Re: Remediation Work Plan Review:
Mariah Foods, Inc., Columbus, IN
VRP# 6970606

By this letter, Mariah responds to IDEM's comments to Mariah's Remediation Work Plan ("RWP"), dated October 10, 2002, and incorporates the further comments by IDEM and agreement reached between Mariah and IDEM on December 9, 2002. Included below are IDEM's comments and Mariah's reply for easier reference.

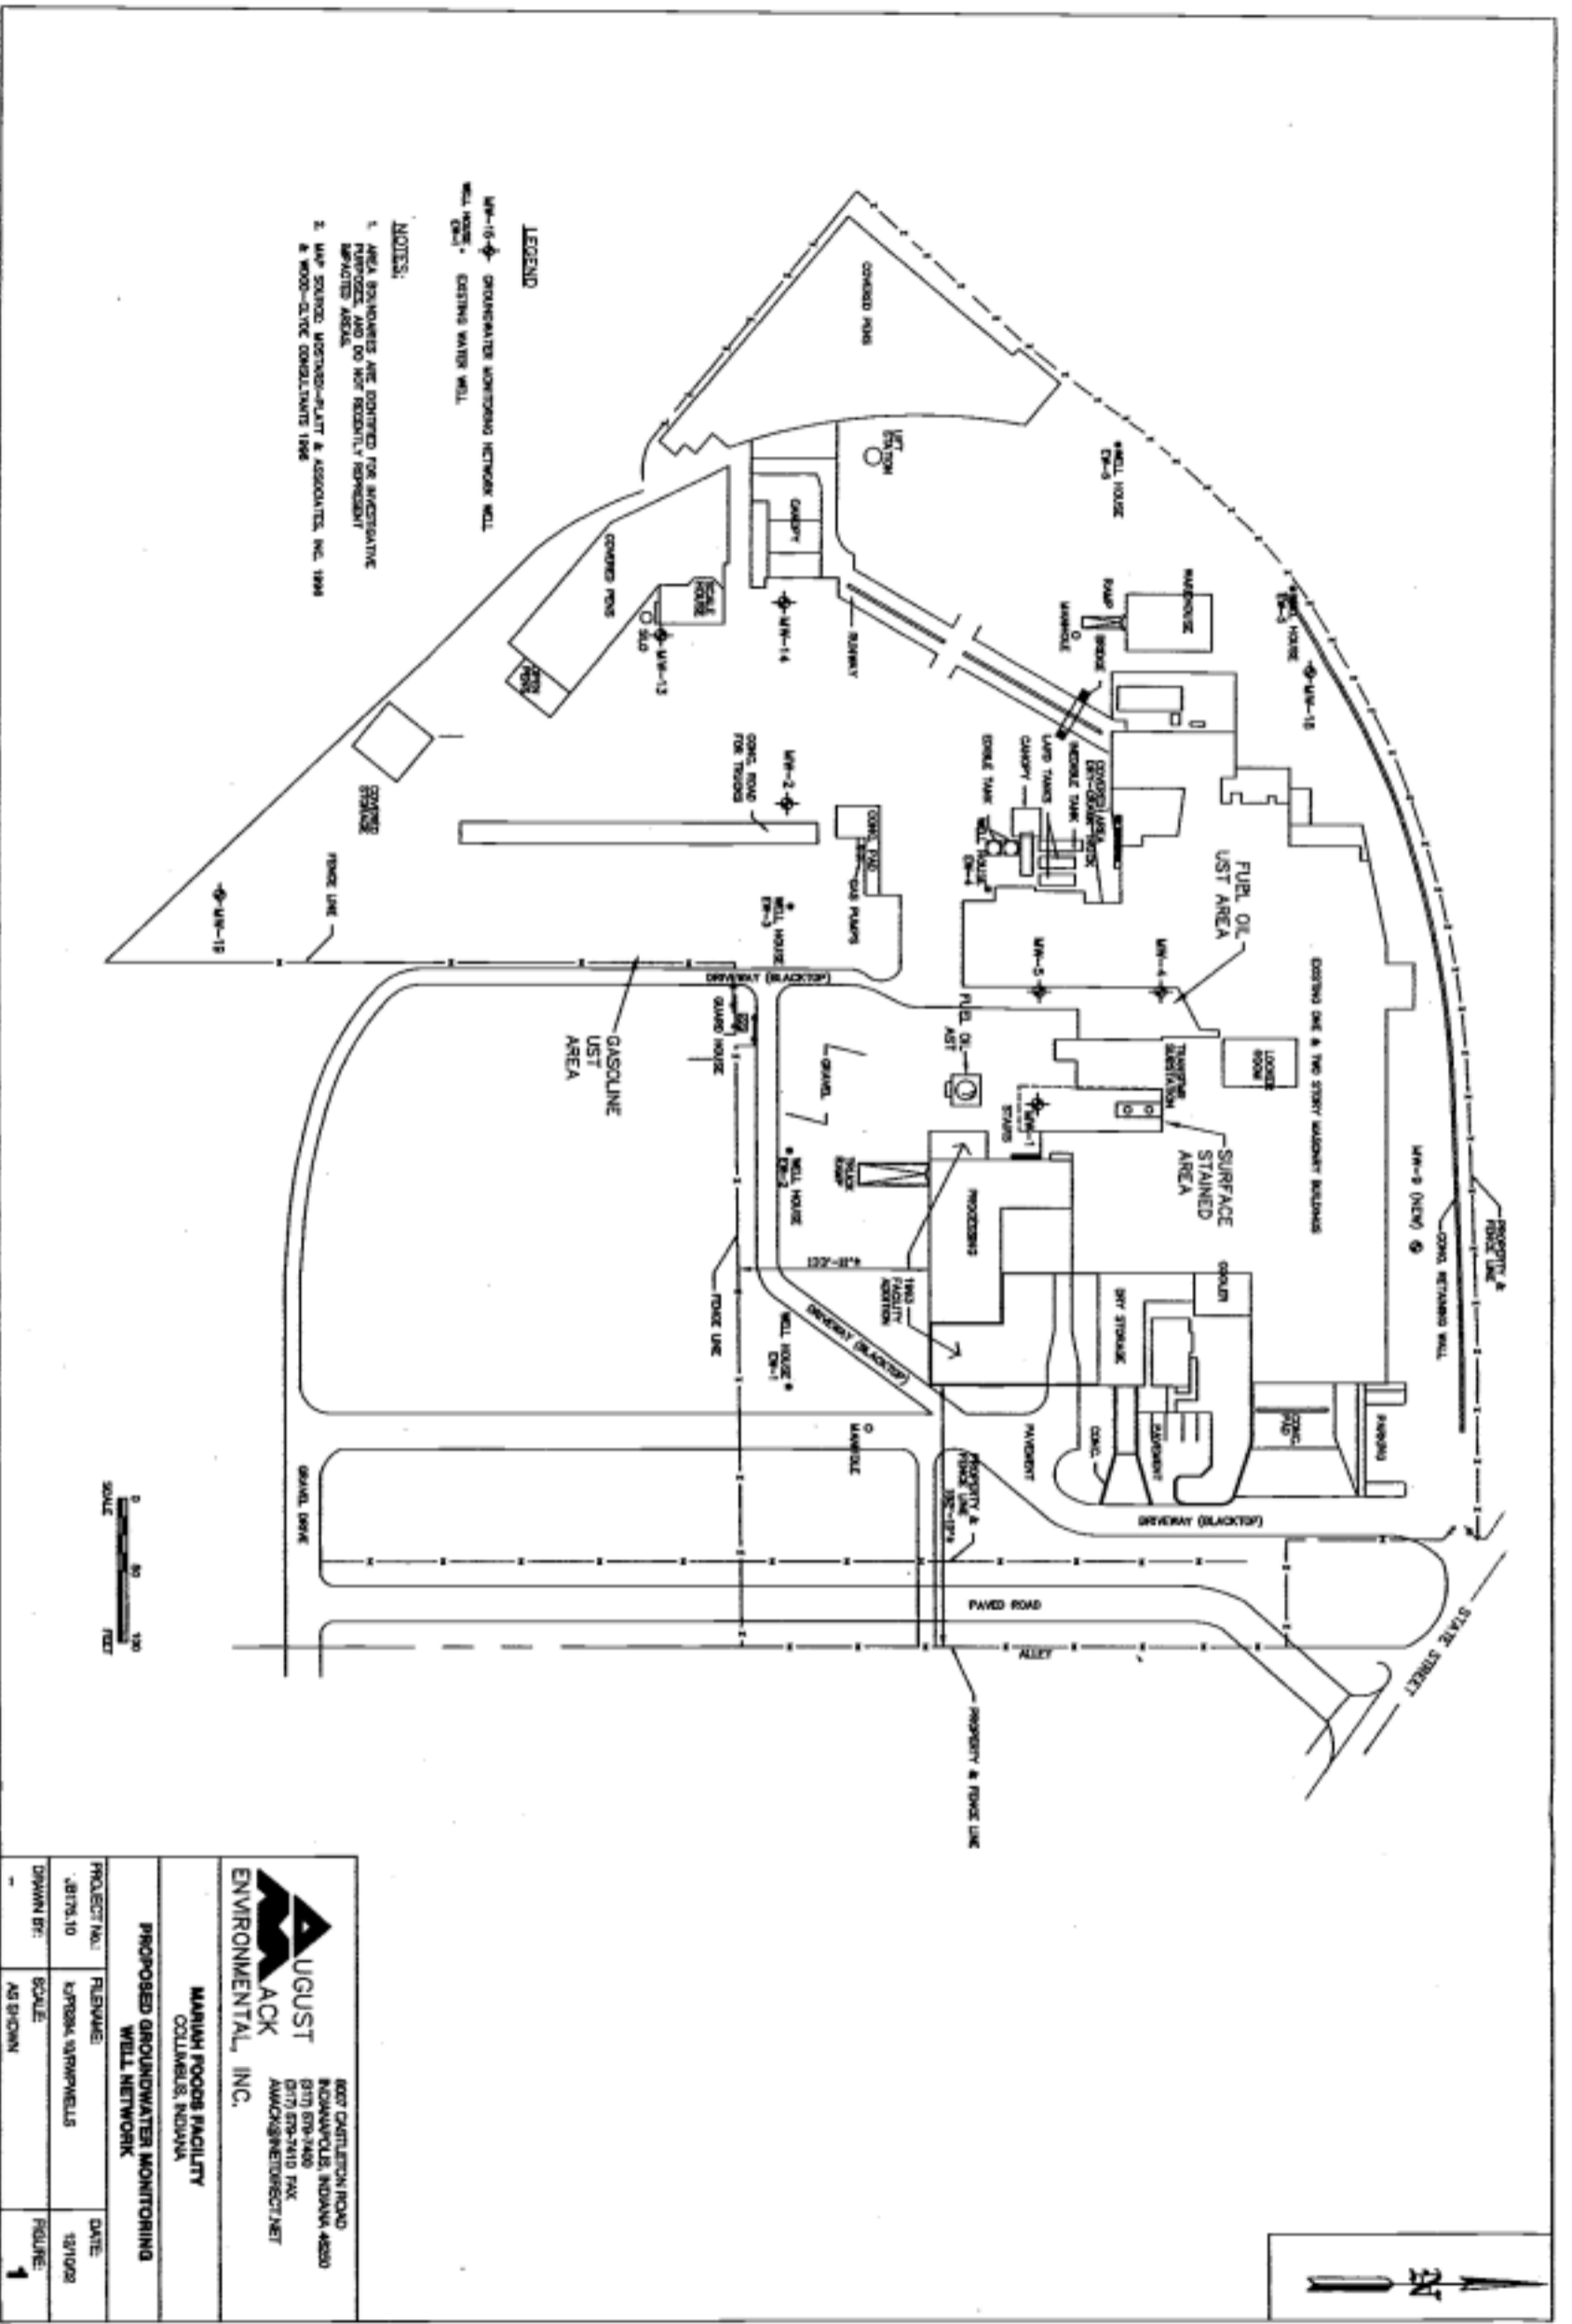
4. The proposed number of monitoring wells to be used for confirmation sampling is insufficient to cover the entire site. Monitoring wells MW-18, 19 and 20 should be added to the monitoring well network for these events. Also, MW-8, which was listed as being damaged or destroyed, should be replaced as the most recent sample from this well had a reported benzene concentration of 1100 ppb. MW-8 was located down-gradient from the former gasoline UST area and from MW-2, which has historically had high levels of VOCs. There may also be a need for an up-gradient well to replace MW-9.

REPLY: Mariah disagrees that the number of monitoring wells it proposed is insufficient, but based on discussions with IDEM on December 9, 2002, Mariah will revise its sampling plan to address IDEM's concerns. Mariah proposes to sample MW-1, MW-2, MW-4, MW-5, MW-13, MW-14, MW-18, MW-19. In addition, Mariah will rebuild and sample MW-9 or drill a new well in its approximate location. (See Proposed Groundwater Well Network, attached as Figure 1.)

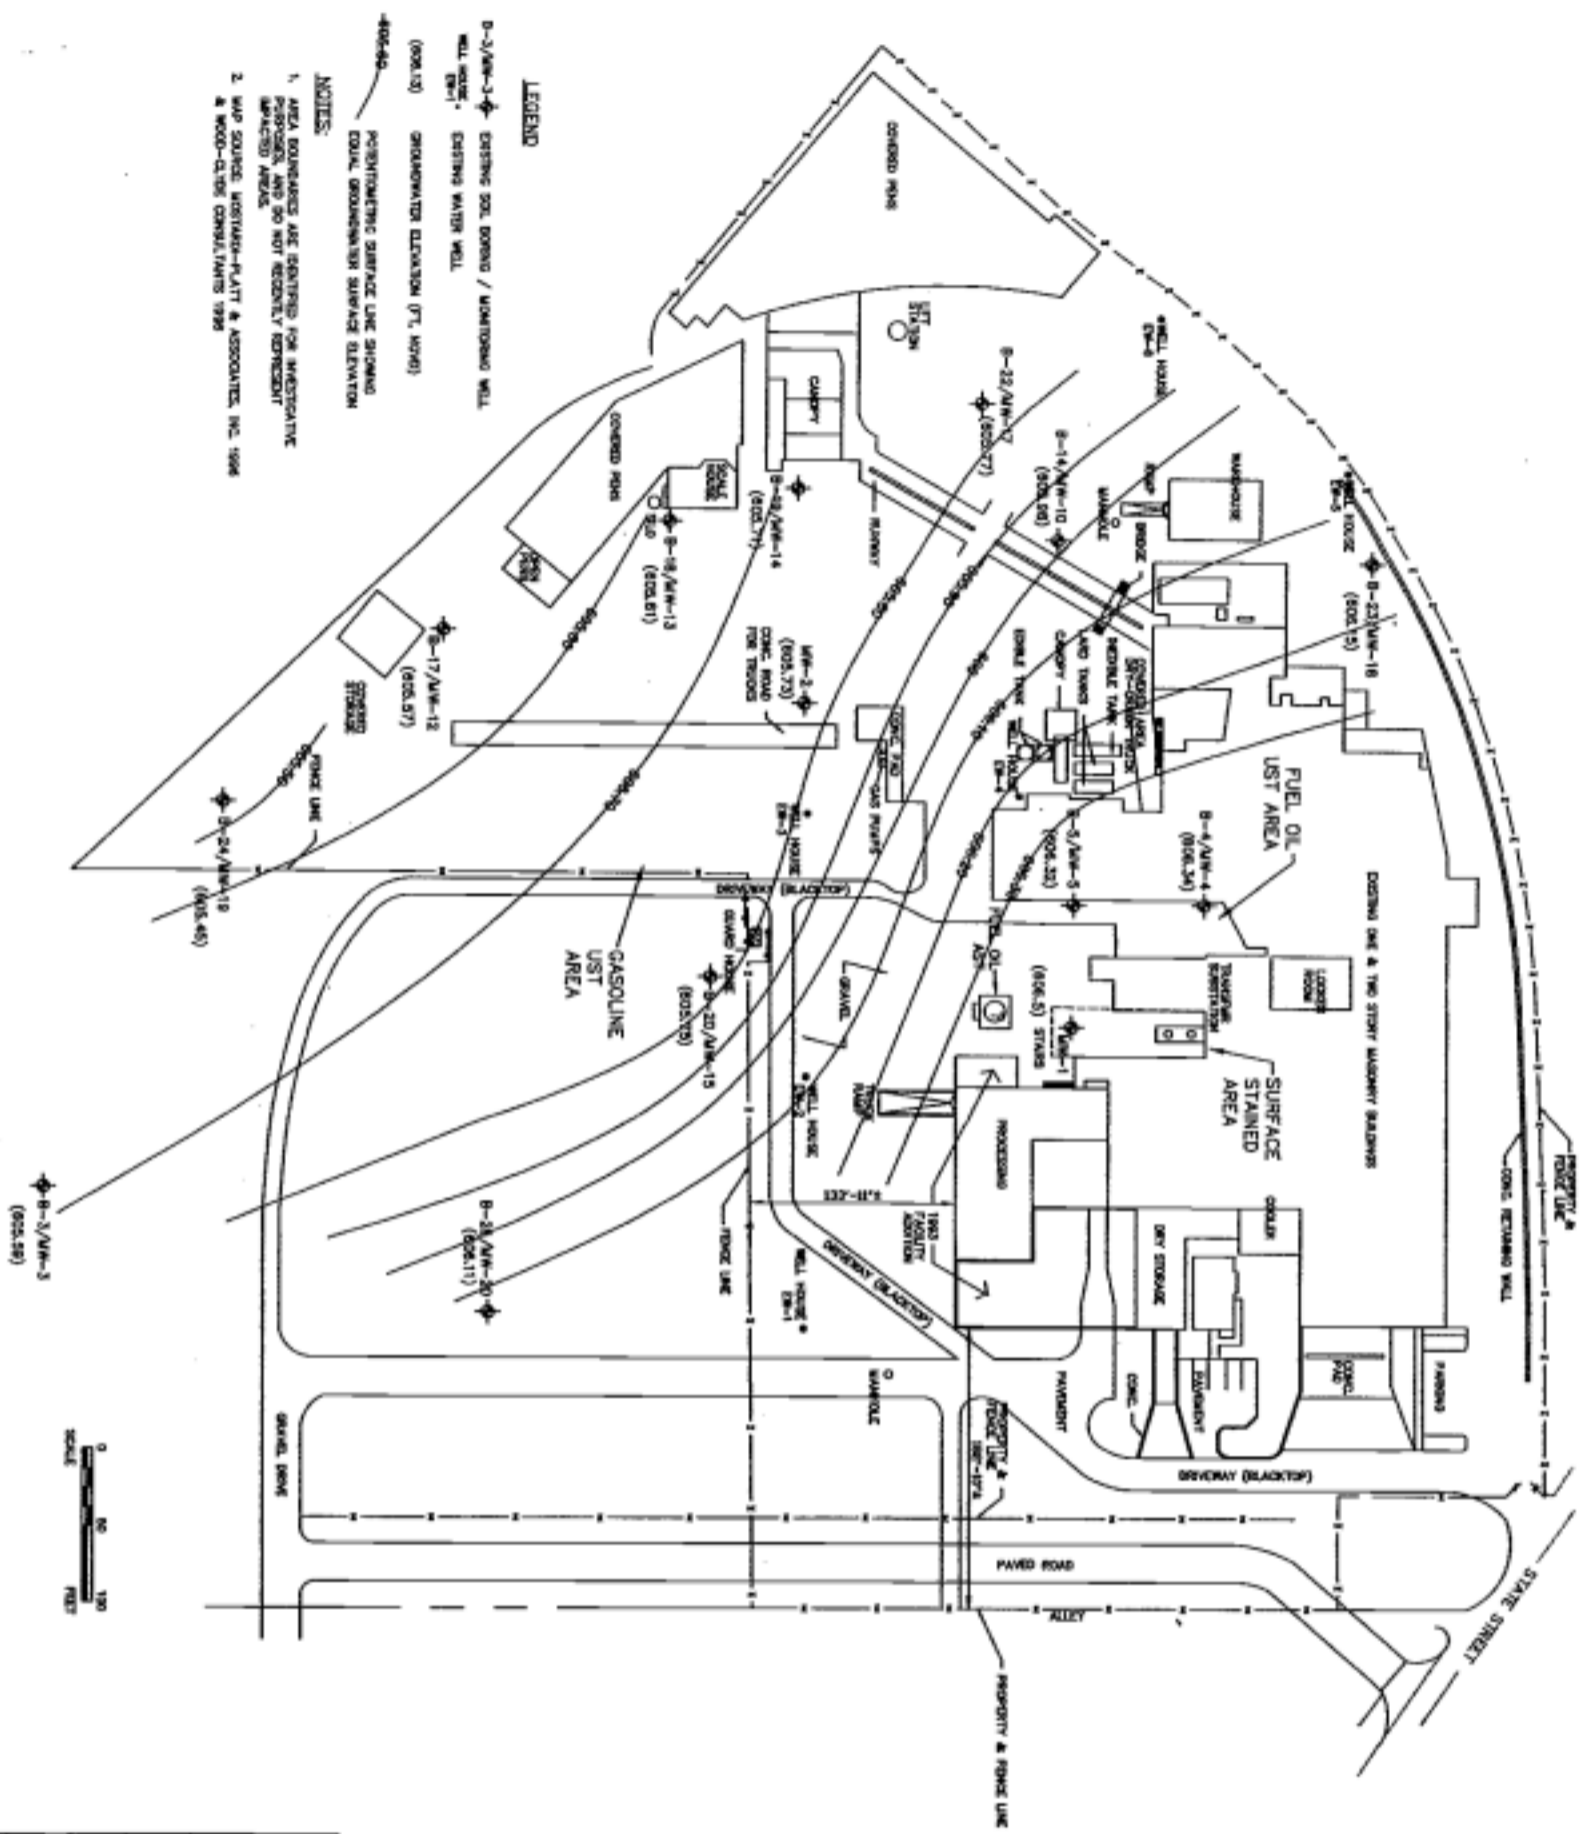
6. Please provide groundwater flow maps for the recent sampling events. The presumed flow direction of northwest to southeast seems to be based on one sampling event performed nearly six years ago.

REPLY: August Mack has redrawn the groundwater flow maps based on the July 26, 2001 sampling event, confirming the southwest direction of groundwater flow. (See Groundwater Elevation Map, attached as Figure 2.)
